**Analysis of**  
**Draft Closure / Post-Closure Permit for Coal Combustion Residuals**  
**Permit No. 057-026D (CCR)**

**Georgia Power Company**  
**Plant Hammond**  
**Surface Impoundment AP-3**

FIGURE 3, CROSS SECTION,  
WEST-TO-EAST (CENTRAL)

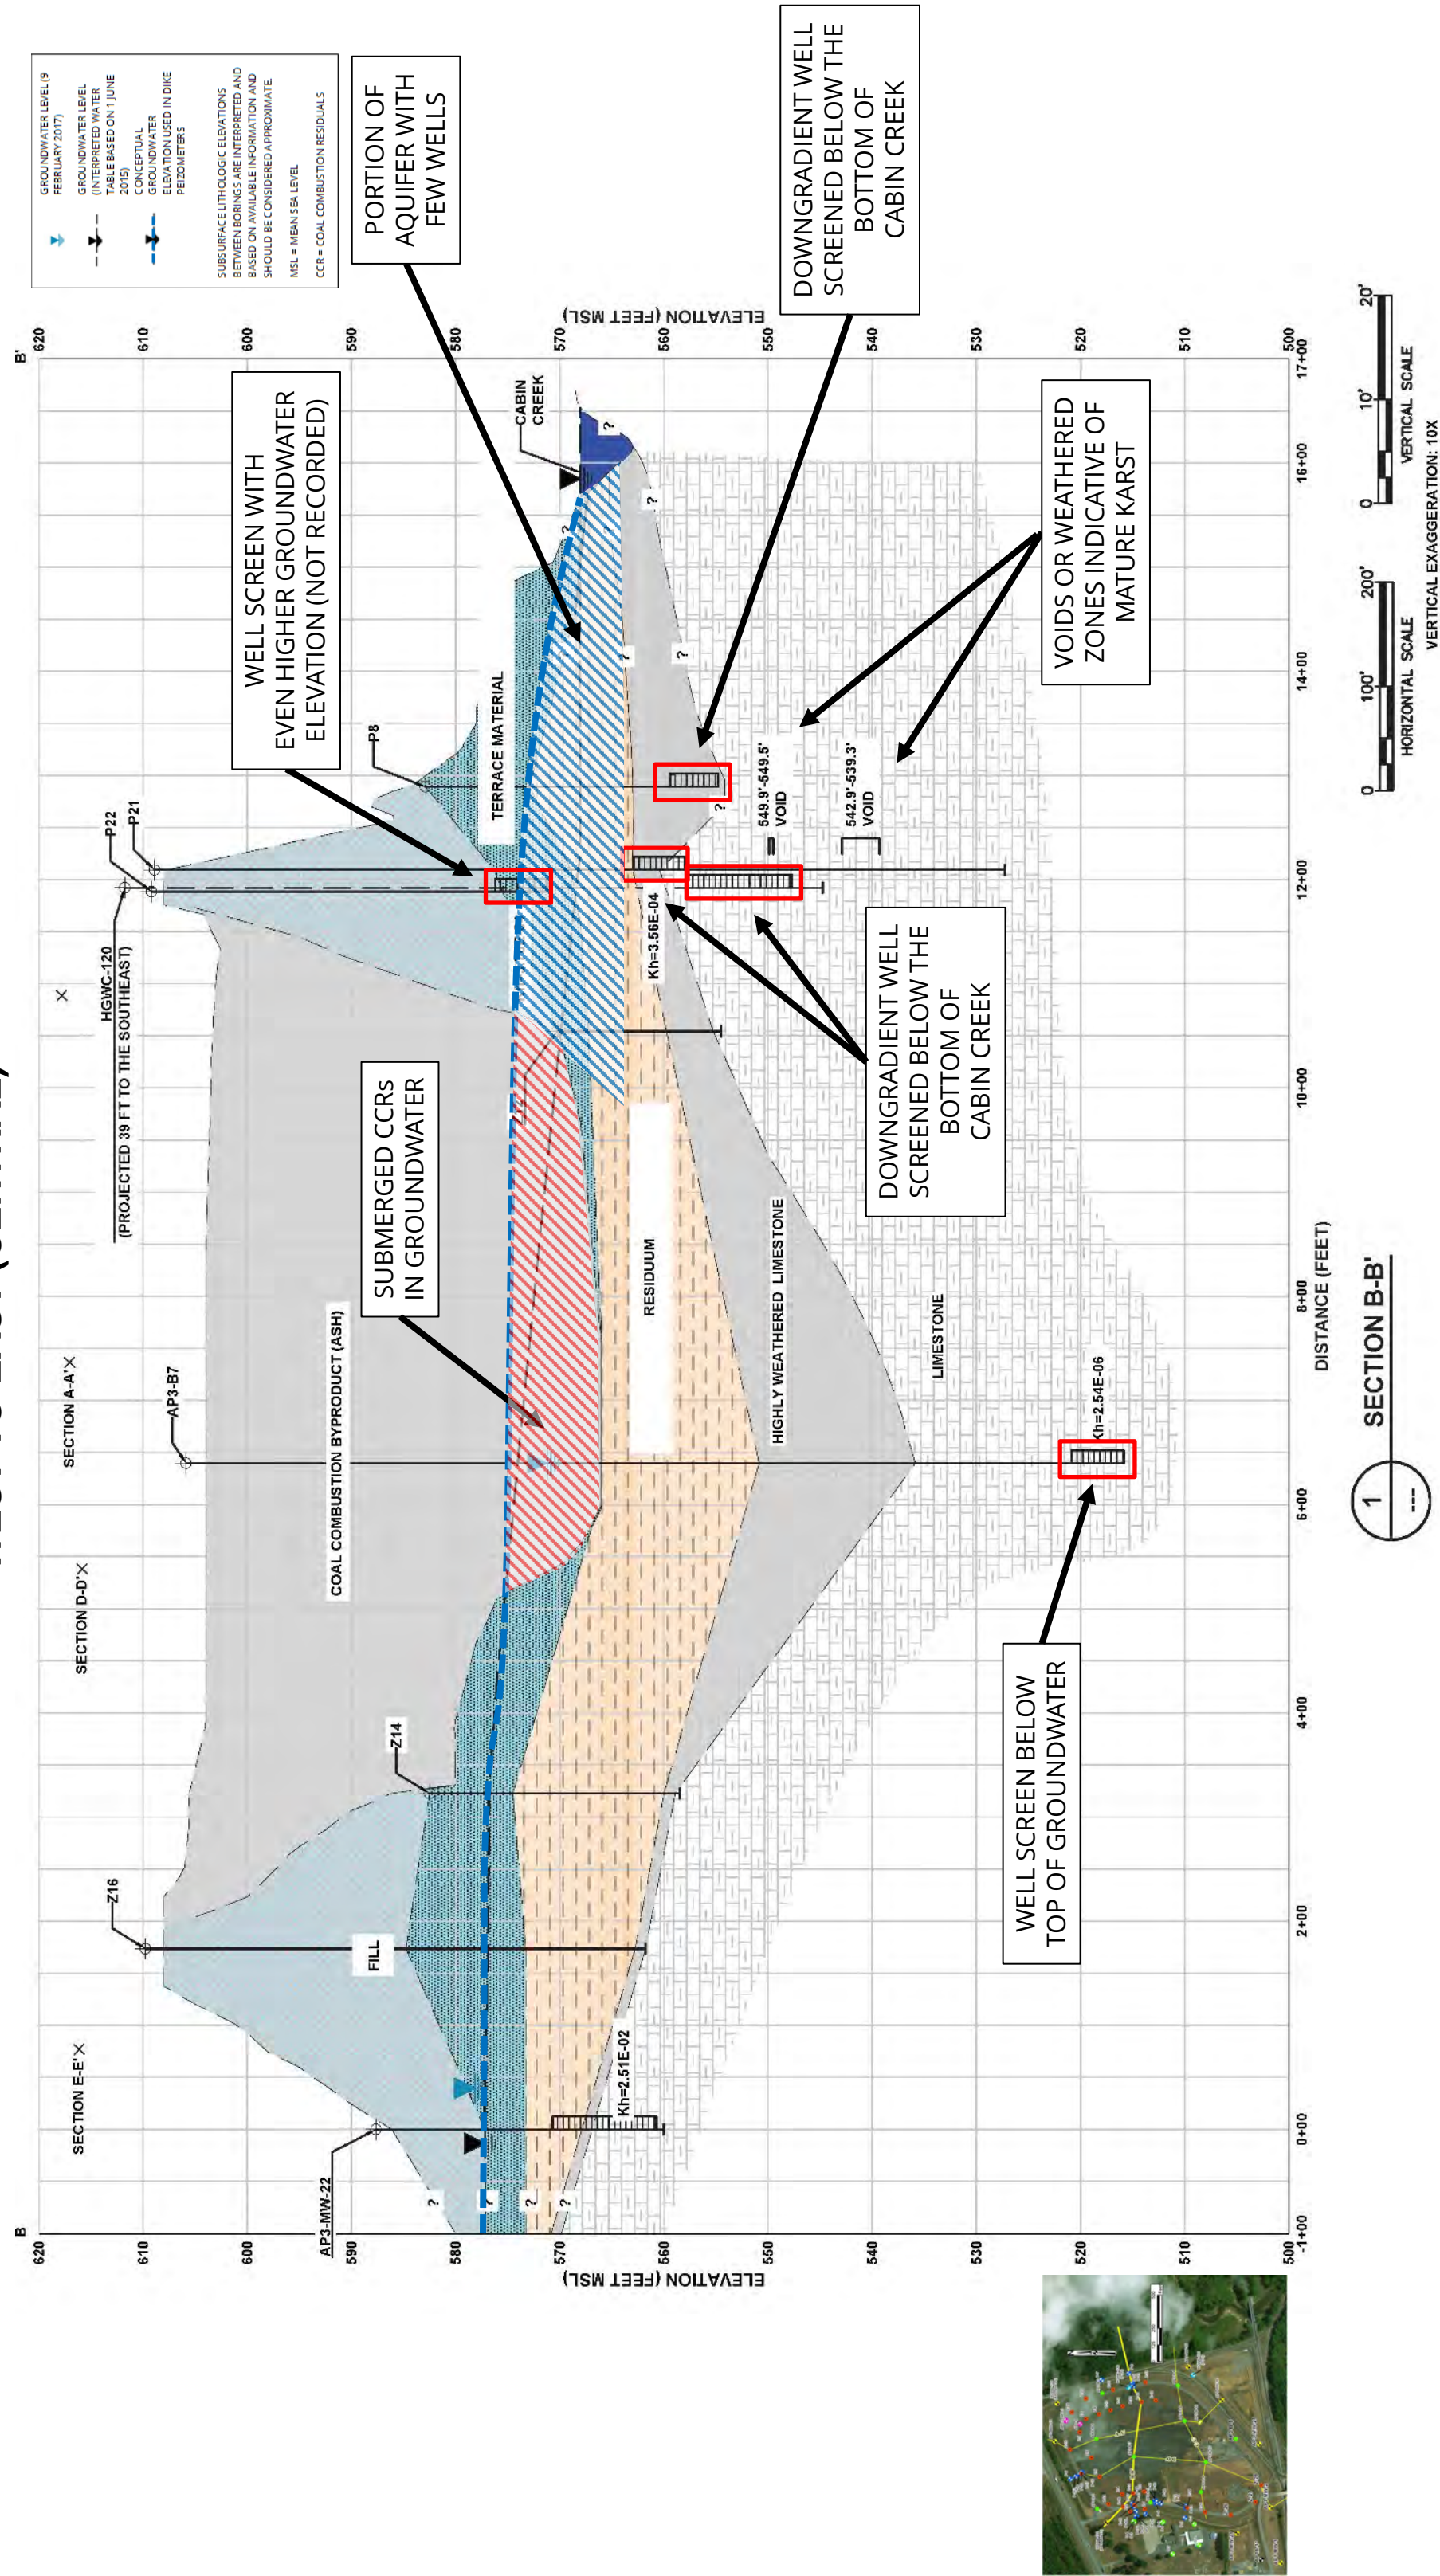
- As **Figures 2 and 3** illustrate, voids and zones of soft drilling or no recovery up to 20 feet were reported.
  - Voids in the bedrock were commonly filled with mud, clay, and sediment.

4. As clearly illustrated in **Figures 2 and 3** and as certified by Georgia Power, AP-3 does not meet the location restriction for Placement Above the Uppermost Aquifer (Rule 391-3-4-.10(3) and 257.60)<sup>20</sup> because the CCRs are located too close to (and within) the uppermost aquifer. Both the US EPA and Georgia CCR Rules require at least five-feet separation between the CCRs and the uppermost aquifer. Further, the 25-acre disposal unit was not constructed with a liner.<sup>21</sup> Without a liner and being so close to the uppermost aquifer, the groundwater has been especially prone to

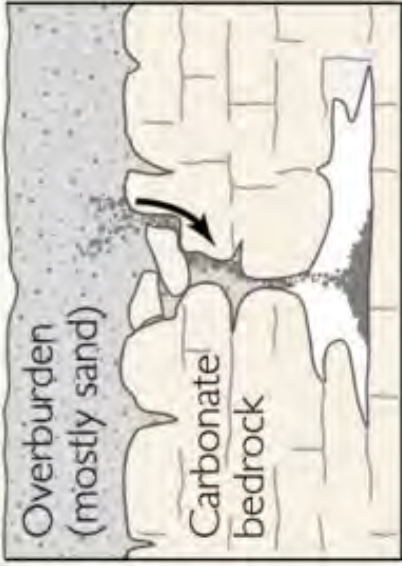
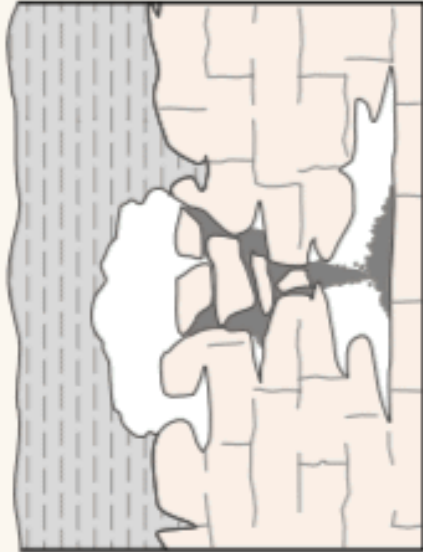
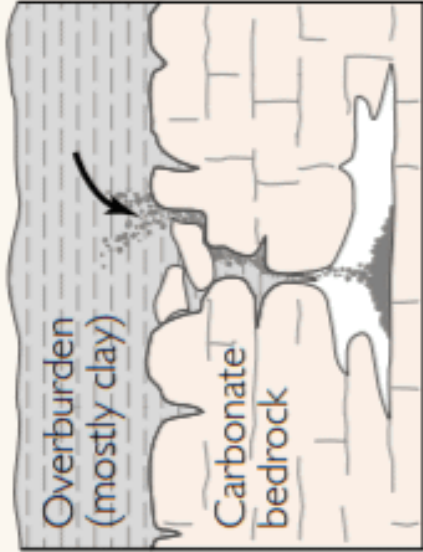
- Georgia Power's claim that neither the Coosa River nor Cabin Creek can "undercut" AP-3 as its logic as to why sinkholes won't form in the future, fails to understand basic karst hydrogeology principles of cover collapse and cover subsidence sinkhole formation and the AP-3 conditions that could contribute to both processes that could result in contaminants being mobilized from the closed impoundment. "Undercutting" can occur from the bottom-up with the rise and fall of groundwater.

- The apparent absence of an *observed* [emphasis added] additional sinkhole collapses since the late 1970s does not mean that slow subsidence sinkholes are not occurring; that the risks for future collapses have been mitigated; or that another sudden sinkhole collapse is unlikely in the future. CCRs can be released quickly in a sudden collapse sinkhole scenario and also slowly in a cover subsidence scenario. Both collapse scenarios can result in significant loss of CCRs to groundwater and to off-site impacts.
